EXAMPLE EVALUATION OF A PERMIT APPLICATION FOR A
PROPOSED HAZARDOUS-WASTE LANDFILL IN
EASTERN ADAMS COUNTY, COLORADO

Water-Resources Investigations Report 86-4131

Prepared in cooperation with the
U.S. ENVIRONMENTAL PROTECTION AGENCY

Figure 2.--Geologic section A-A'. (Trace of section shown in figure 4.)

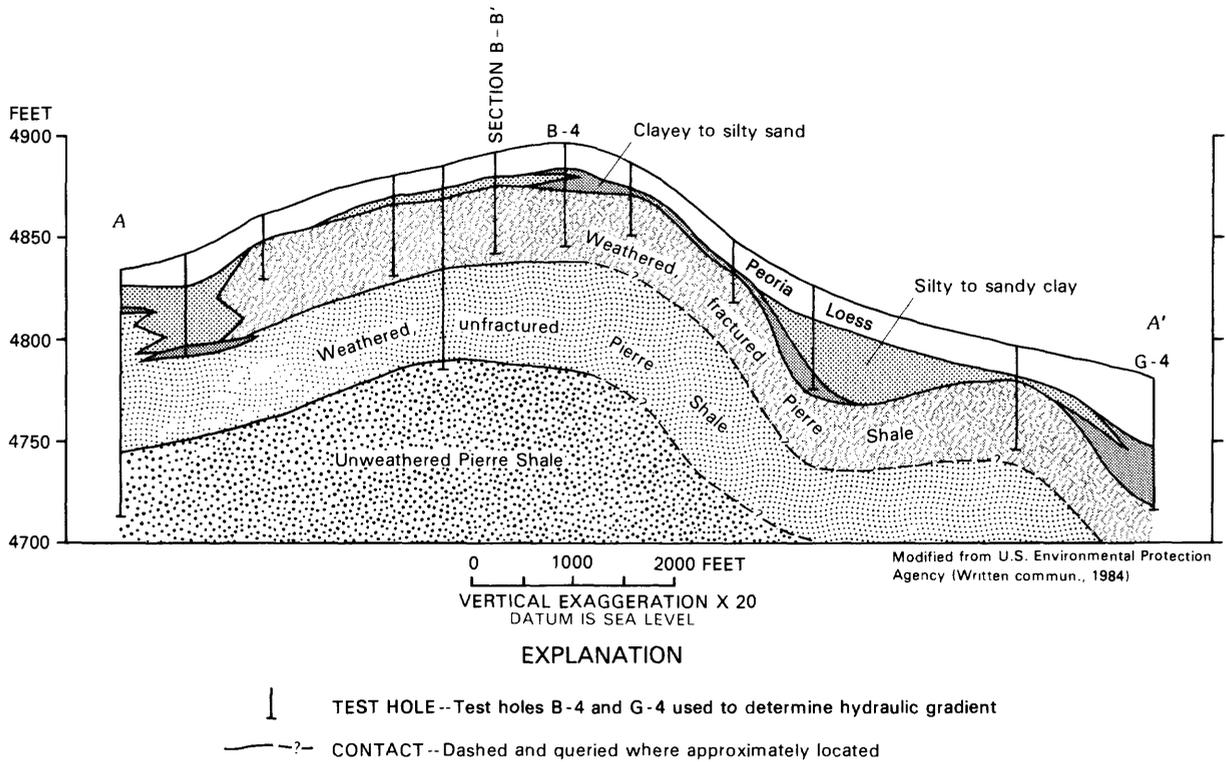
The applicant's argument that the sand intervals represent several individual sand lenses is based on the fact that they occur at differing altitudes. However, if the sand zones encountered during drilling are continuous, the sand lens would dip at no more than 4° (about 7-percent slope), as shown in figures 2 and 3.

2. Representations of wells and sample holes shown on the geologic sections (included in the application) do not match the data supplied in the sample logs (also included in the application) in all cases.

Because the data supplied are insufficient to define the hydraulic gradient, the average land-surface slope, measured between test holes B-4 and G-4 (fig. 2), was used as the hydraulic gradient. This technique, according to the Location Evaluation Methodology, may overestimate hydraulic gradient by as much as 100 percent. However, assuming the sand lens is saturated for part of its thickness and is unconfined between the two test holes used for the time-of-travel estimates, the minimum hydraulic-head difference would be the difference in altitude between the bottom of the sand zone at test hole B-4 and land surface at test hole G-4. This difference is indicated by the liberal hydraulic-gradient estimate.

Figure 4.--Distribution of sand within and adjacent to the site of the proposed landfill.

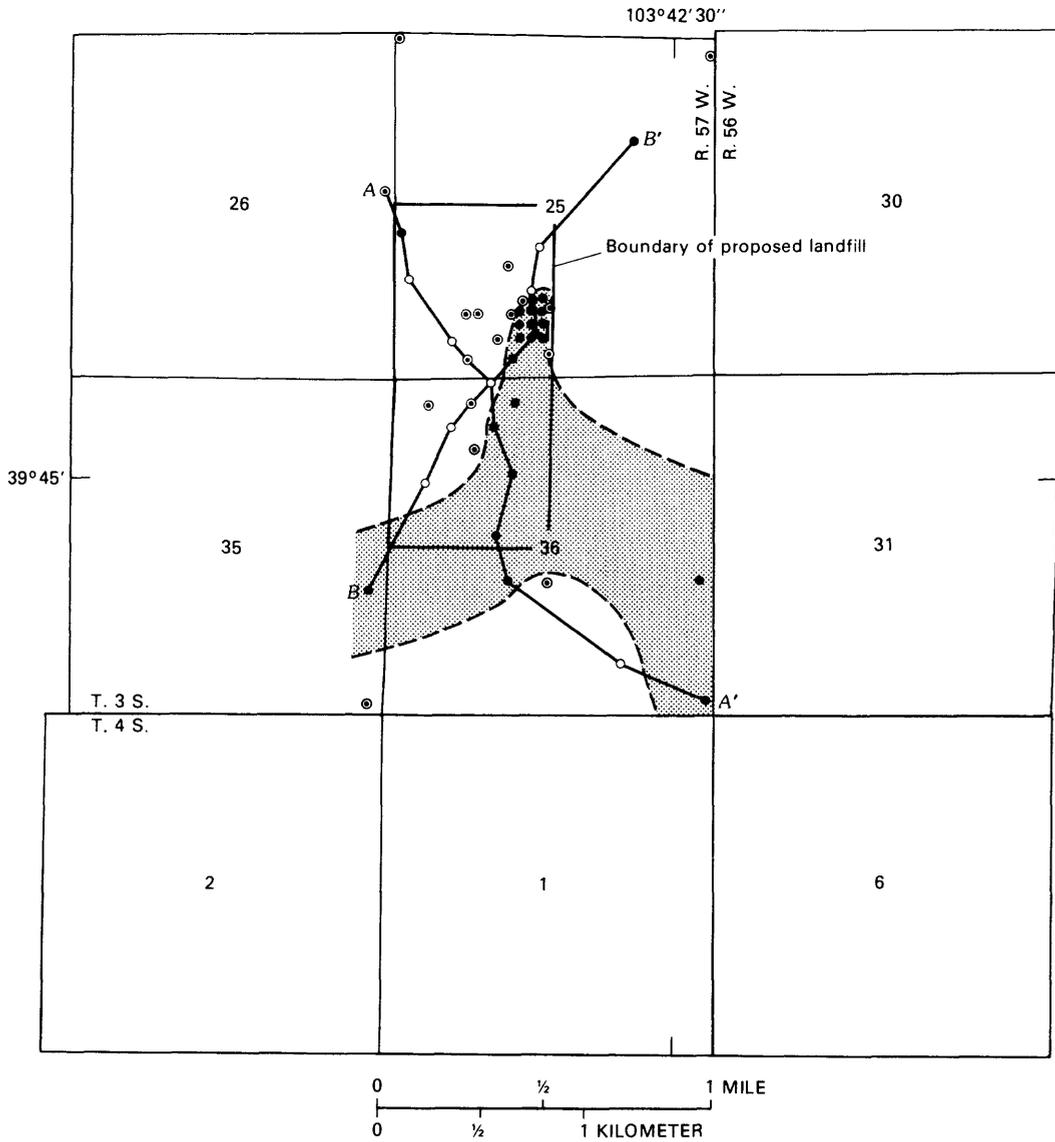
Sand deposits encountered in the southeastern part of the proposed site (fig. 4) are considered in this report to be continuous. Of the test holes that penetrated the sand, the three drilled at low-altitude sites penetrated water-saturated sand. The water levels in these test holes indicate a hydraulic gradient toward the southeast, approximately equal to the land-surface slope in magnitude and direction. A comparison between these water levels and those in wells completed in the upper part of the Pierre Shale indicate that the water levels in the sand lens are considerably higher and probably are representative of water perched on underlying clay and claystone zones. The permeable sand zones provide the most probable pathway for contaminants leaching from the site, but more core-sample and water-level data are necessary to adequately define the system hydraulics.
